AGENDA

MILWAUKIE DESIGN AND LANDMARKS COMMITTEE Monday, August 7, 2017, 6:30 PM

- 5.0 **Public Meetings—**Public meetings will follow the procedure listed on reverse
 - 5.1 Recommendation Hearing: Willamette Greenway review for Kellogg Creek replacement bridge in Riverfront Park (Land use master file #WG-2017-003)

- 5.2 Recommendation Hearing: Downtown Design review for new mixed-use development at 2036 SE Washington St (Land use master file #DR-2017-001)
- 6.0 **Worksession Items**

SOUTH BANK GRADING PLAN

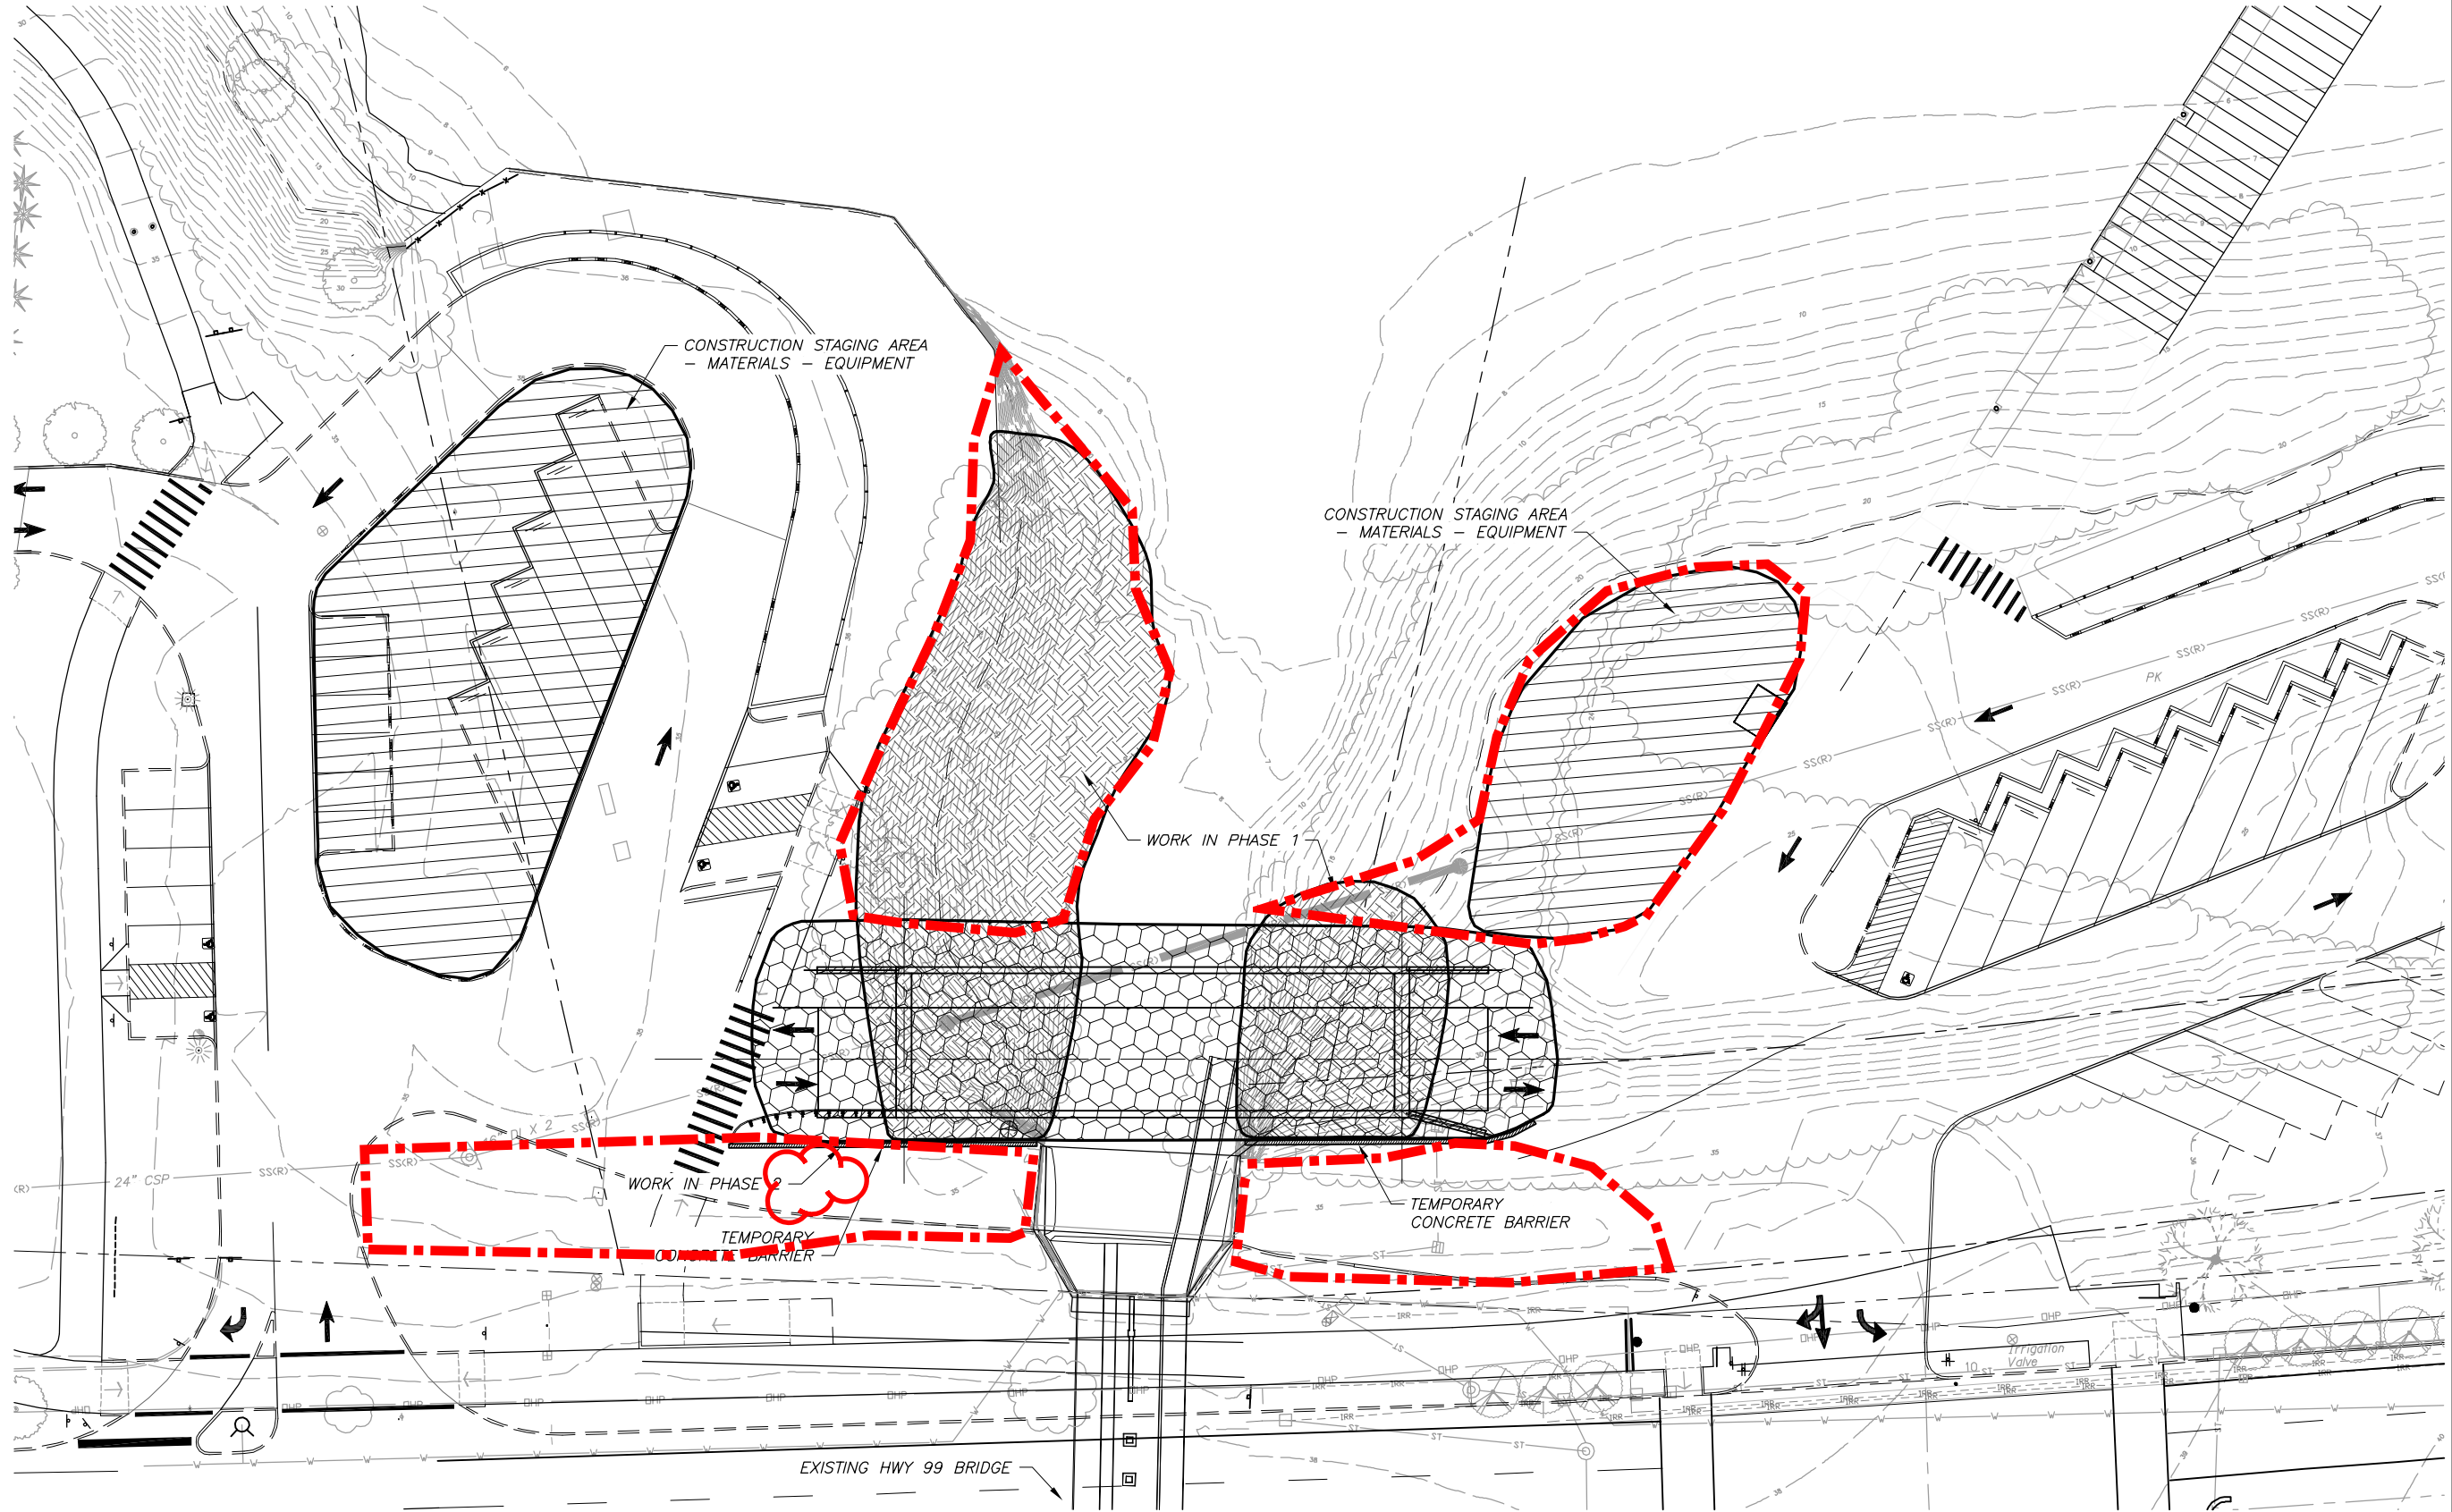
- The Proposed Site Plan Cross Section P2, sheet 7B, indicates trees planted on the south bank but the Riverfront Park Planting Plan detail (sheet 5) calls out small shrubs and groundcover. Would like to see consistency in the planting plans.

Figure 9. Proposed southern facade elevation

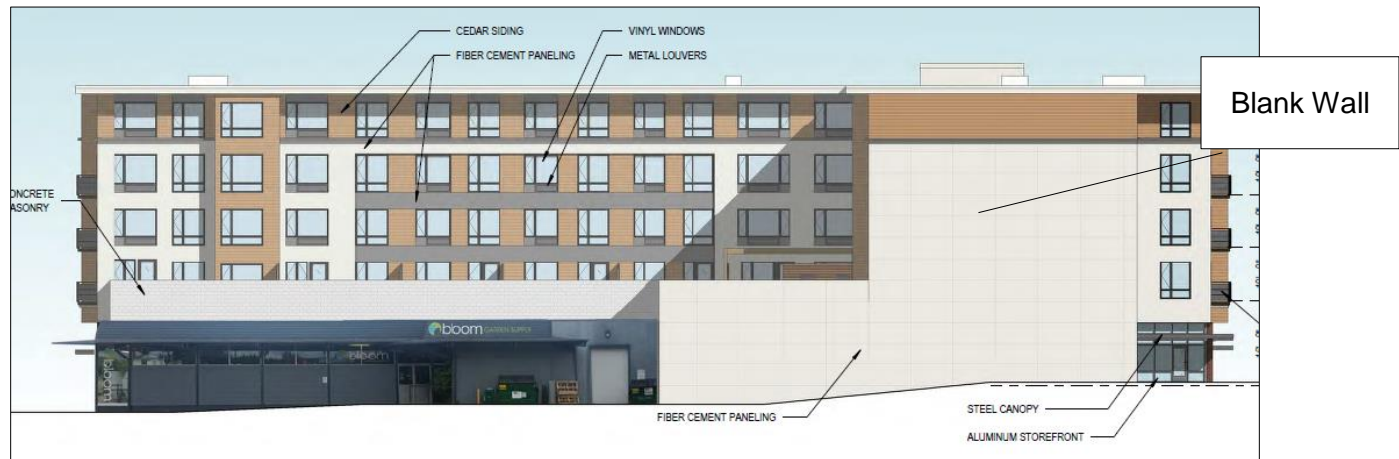
building is located right up to the property line. A condition of approval has been recommended to address this requiring that a mural be installed on the southern-facing wall as well as the northern façade adjacent to the garage entrance door. It is recommended that the Applicant consult with ArtMob in developing the artwork.
